Form C-103
Revised August 1, 2011

SUNDRY NOTICES AND REPORTS ON WELLS (DO NOT USE THIS FORM FOR PROPOSALS TO DRILL OR TO DEEPEN OR PLUG BACK TO A DIFFERENT RESERVOIR. USE "APPLICATION FOR PERMIT" (FORM C-101) FOR SUCH PROPOSALS.)	
1. Type of Well: Oil Well ☐ Gas Well ☒ Other ☐	
2. Name of Operator Chevron USA, Inc.	
3. Address of Operator 6301 Deauville Blvd., Midland, TX 79706	
4. Well Location Unit Letter E : 1980 feet from the NORTH line and 430 feet from the WEST line Section 15 Township 22S Range 37E, NMPM, County Lea	
11. Elevation (Show whether DR, RKB, RT, GR, etc.) 3400' GL

Chevron USA INC respectfully requests to abandon this well as follows:

WELL WORK - CURRENT WELLBORE DIAGRAM

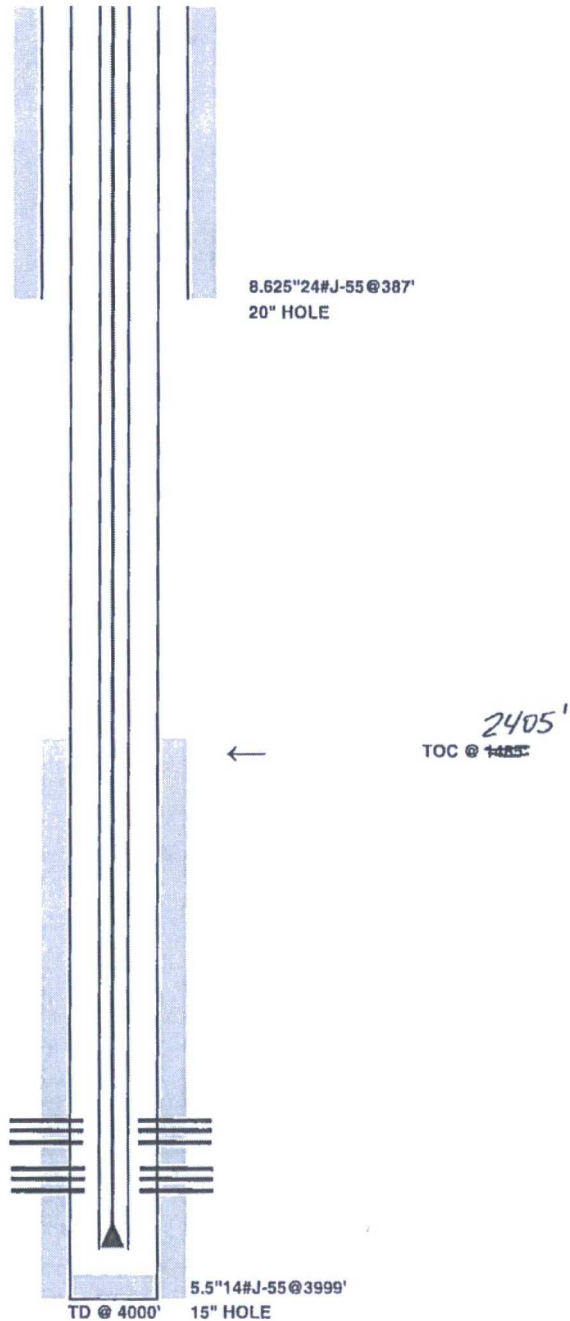
5. If there is pressure on the 5 1/2" x 8 5/8" annulus, discuss with engineer adding a perf & squeeze prior to moving on to step 6, in an effort to isolate the pressure before proceeding uphole → check for pressure prior to STEP 4
